DAY | STOKOSA
ENGINEERING P.C.

March 12, 2021

Re: Hudson Valley Lighting
Grid #6256-02-841673
M.A. Day Job No. 2020.077

In response to the various review letters received by this office, we offer the following responses. Original comments from each letter are italicized. Our responses are in bold.

Grading and Drainage Plan

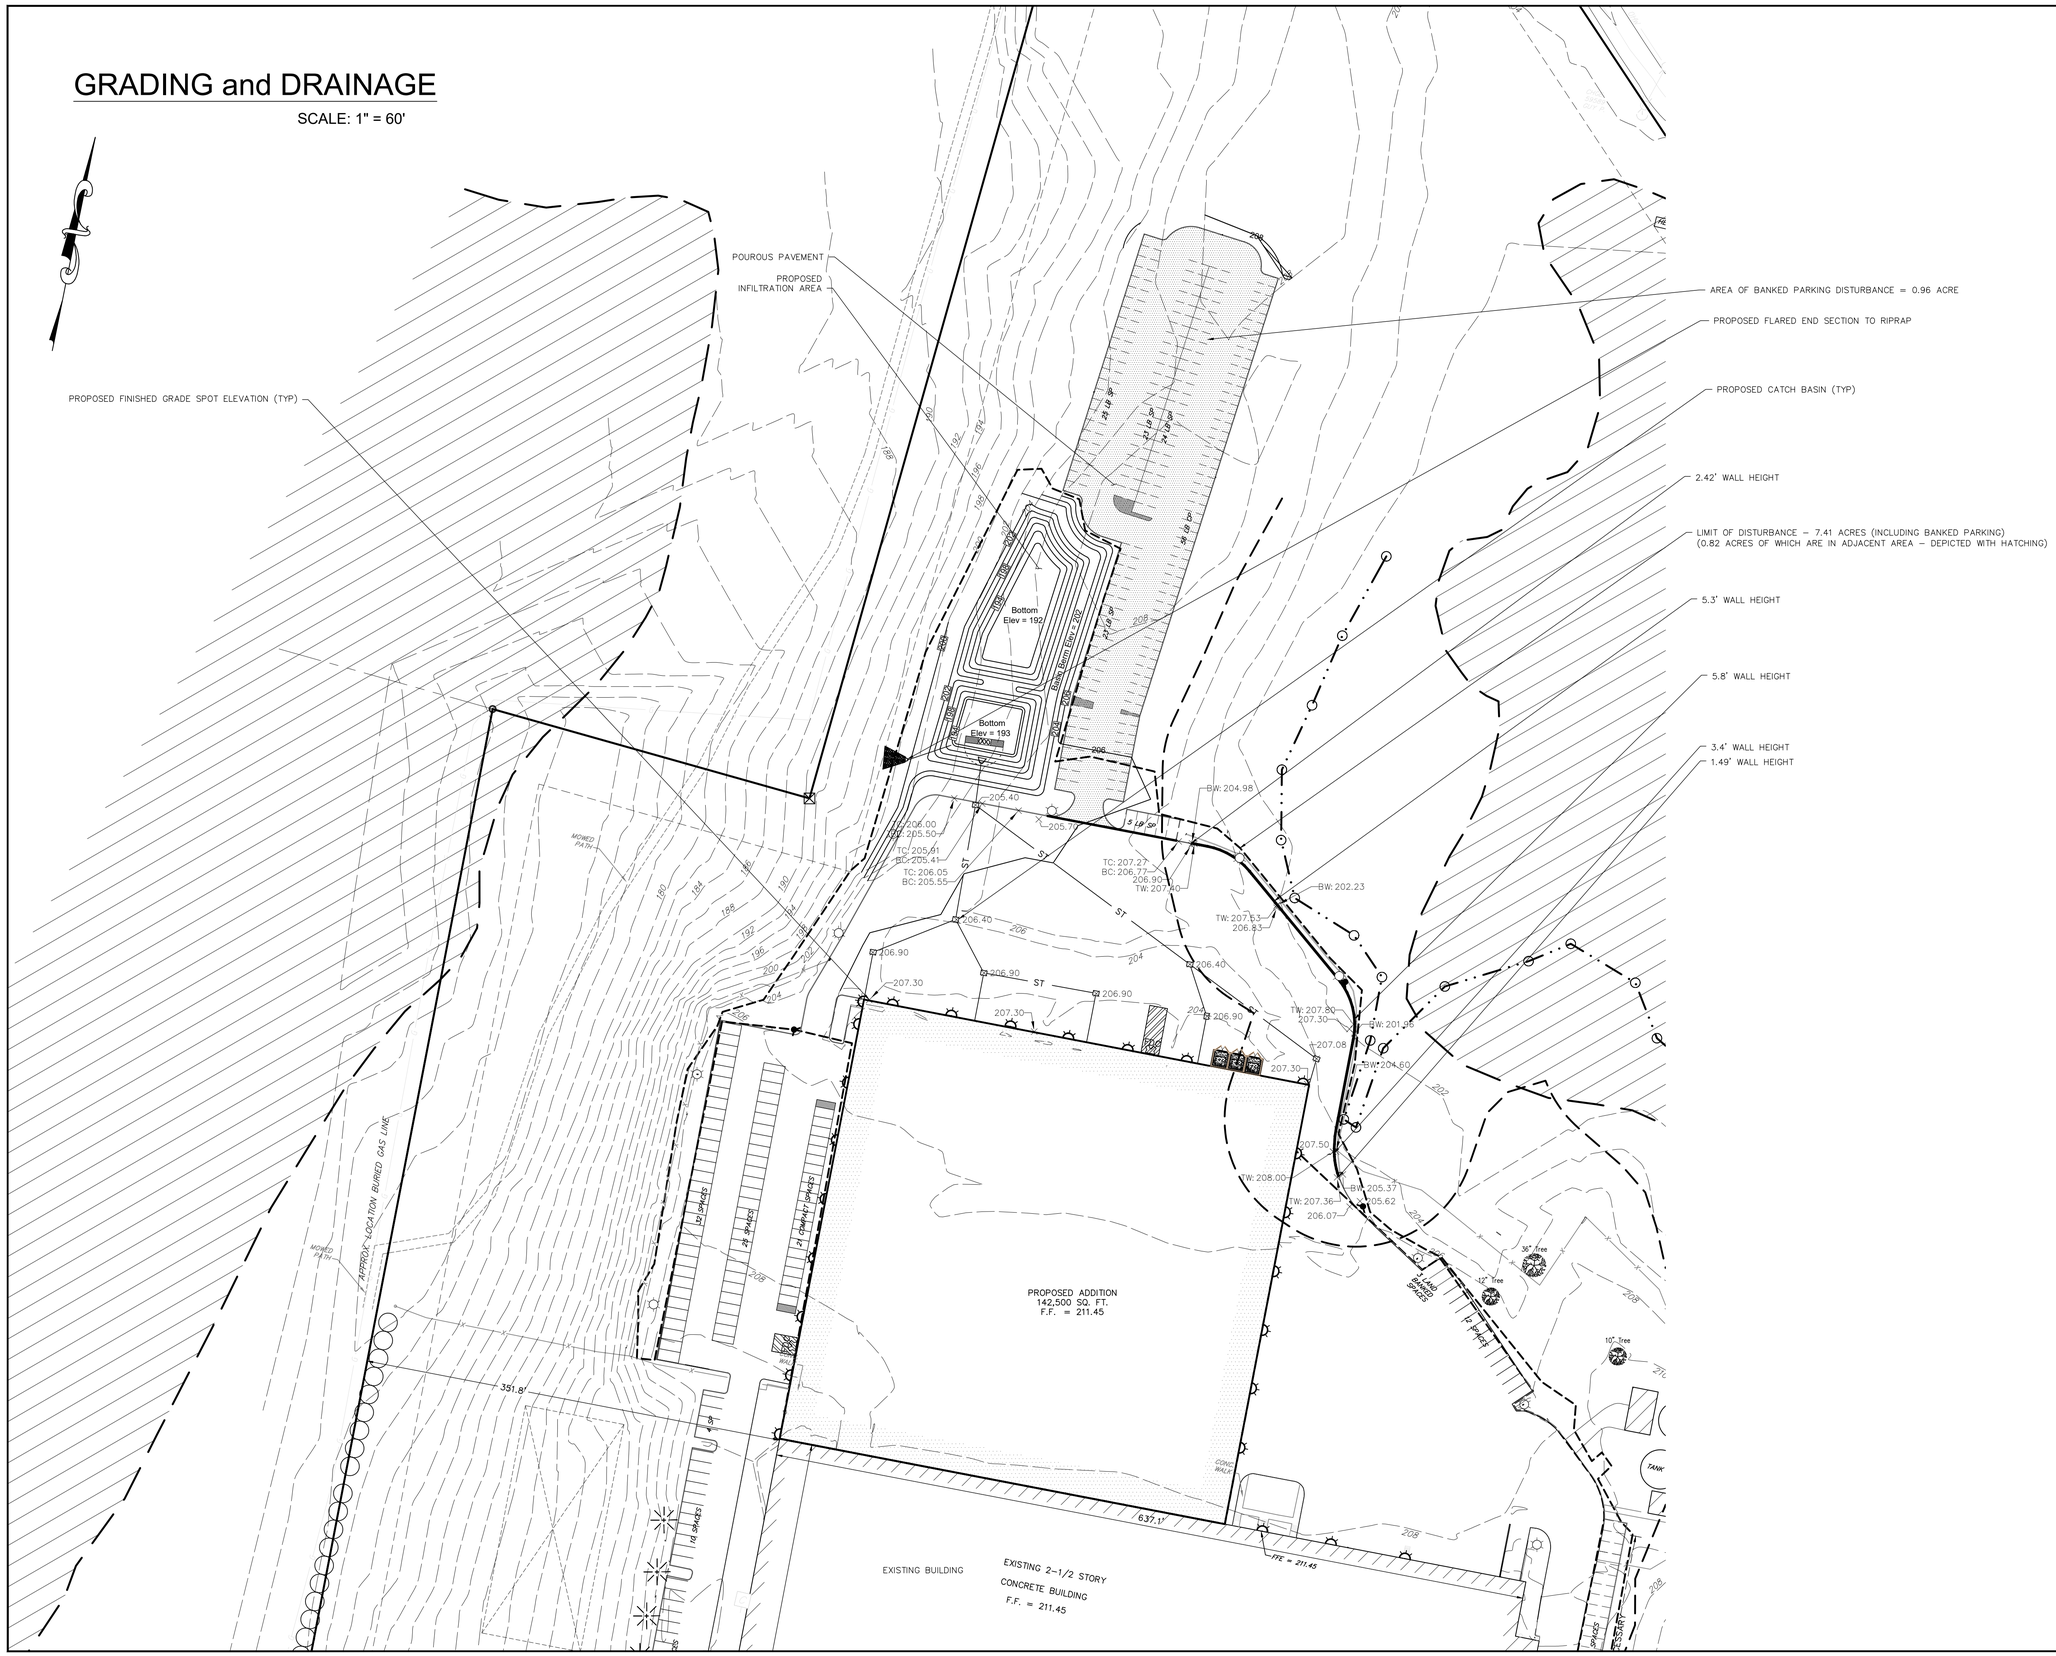
5. *Response to previous comment is noted, upon final design please address the following comments to the Sheet GD.1:*
    a. *Provide construction details for all stormwater management features.*
    b. *Show the location of the proposed temporary swale to corelate with the construction detail.*
    c. *Provide protection around the infiltration chambers throughout the duration of construction.*
    d. *Please label the proposed roof leader locations for clarity; and*
    e. *Please clarify the proposed grading contours in the driveway area around the truck loading and infiltration chambers.*

These items will be provided as appropriate.
6. *Response to prior comment is noted. As previously stated, provide a construction detail for the proposed porous pavement.*

DRAWING
Lighting Plan

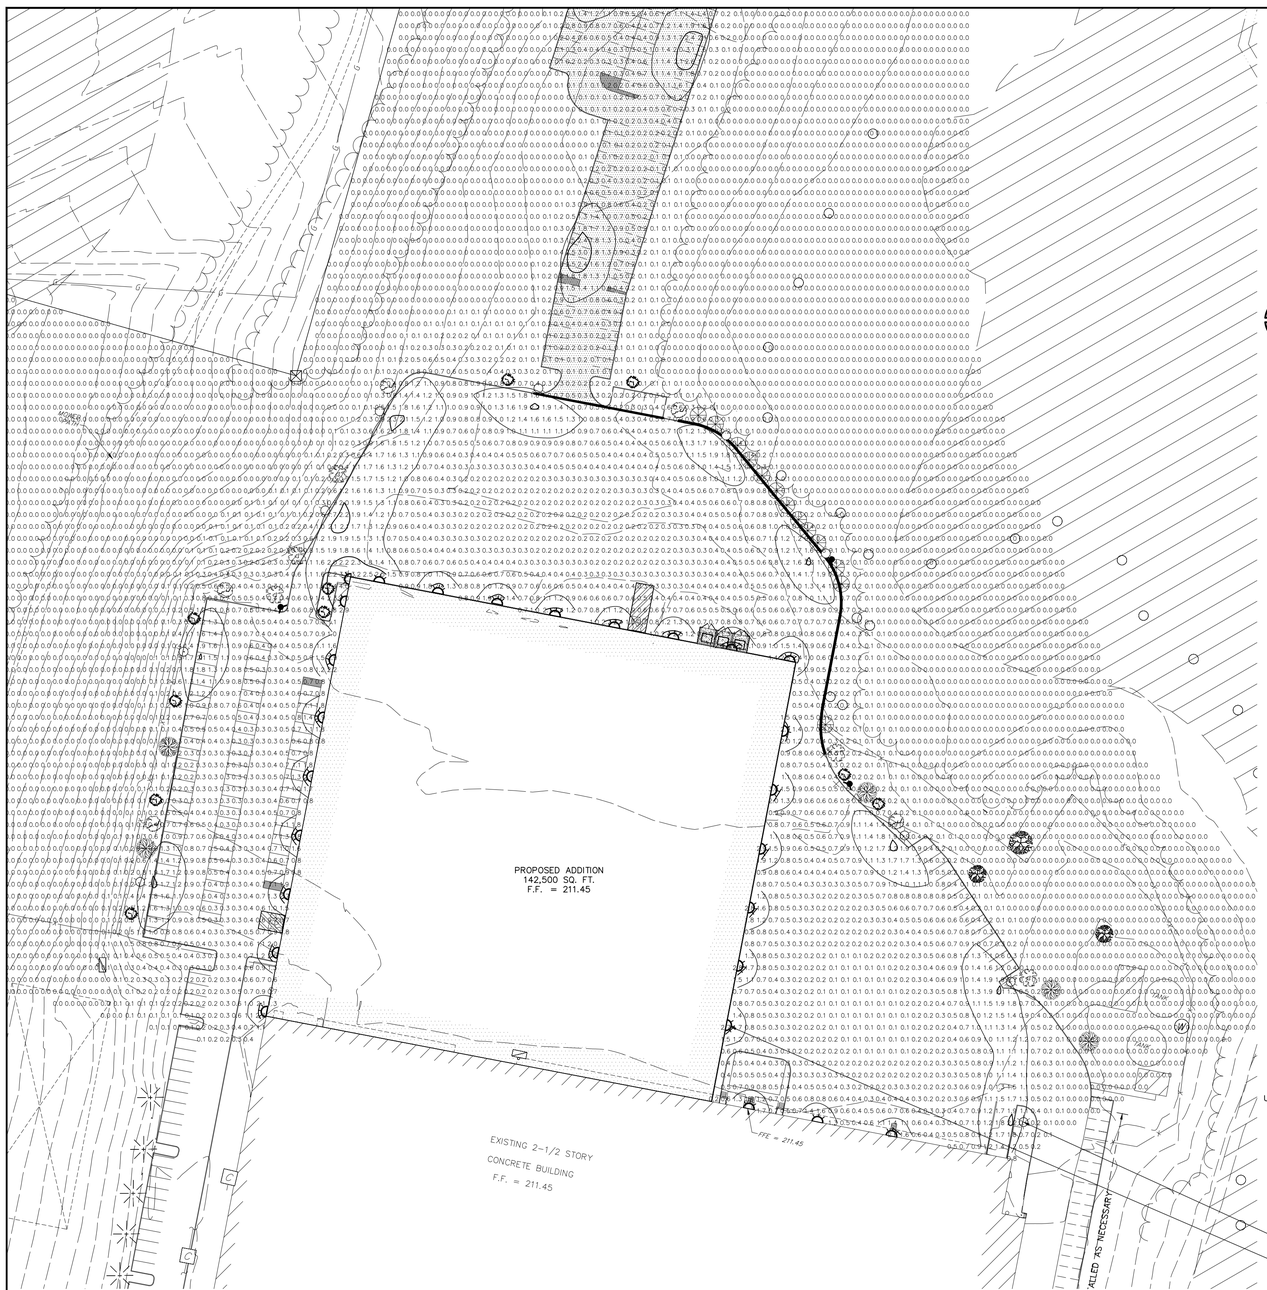
1. - 3. **Comments noted**
4. *Lighting. There are two poles proposed at the north east corner of the parking area. These two poles are a different fixture than the other poles lining the periphery of the parking area. These two poles are proposed at a lower height than the other lights on the property (15' compared to 25' poles along the parking area and 20' wall mounted lights lining the building) and at significantly higher level of illumination than the other lights (12 footcandles compared to 3-4 footcandles on the other poles and 1-1.5 along the building). We question if this is done with intention and if the proposed lighting can be reduced without disruption to proposed activities. Additionally, the applicant should confirm the color temperature of the proposed lighting. In general, we do not recommend color temperatures exceed 3000K. In instances where wildlife, particularly the endangered Indiana Bat, is at risk of impact, a lower color temperature may be desirable.*

The lighting has been modified. The specs are included. Lighting is shown for the banked spaces to the north.
   To the west the grade drops substantially and the tree line is not impacted by spillage. Being the fixtures are type III distribution, spillage to the east tree line is also minimal. The temperature of all fixtures is 3000K and will have dimming and timing control.

DRAWING
Retaining Wall Details

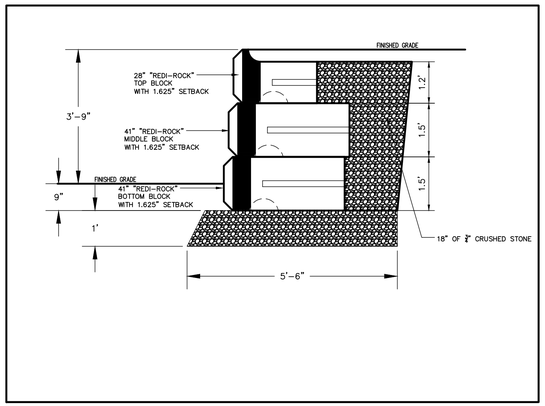
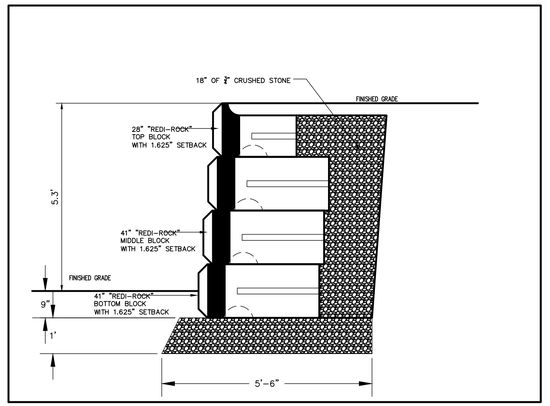
4. *The details of the retaining walls are noted, please specify the location and height of the proposed retaining walls. Please revise the plans to clearly show the full extent of the wall including spot*

elevations and locations of varying heights as shown in the details (i.e., 4' wall, 6' wall, etc.). If the wall is over 4' high, then a note should be placed on the plans stating that retaining walls over 4' high shall be designed by a New York State Licensed Professional Engineer and plans shall be submitted as part of the building permit application.

The location and top/bottom wall elevations can be seen on the grading and utility plans. The wall is on all proposed site plan sheets.
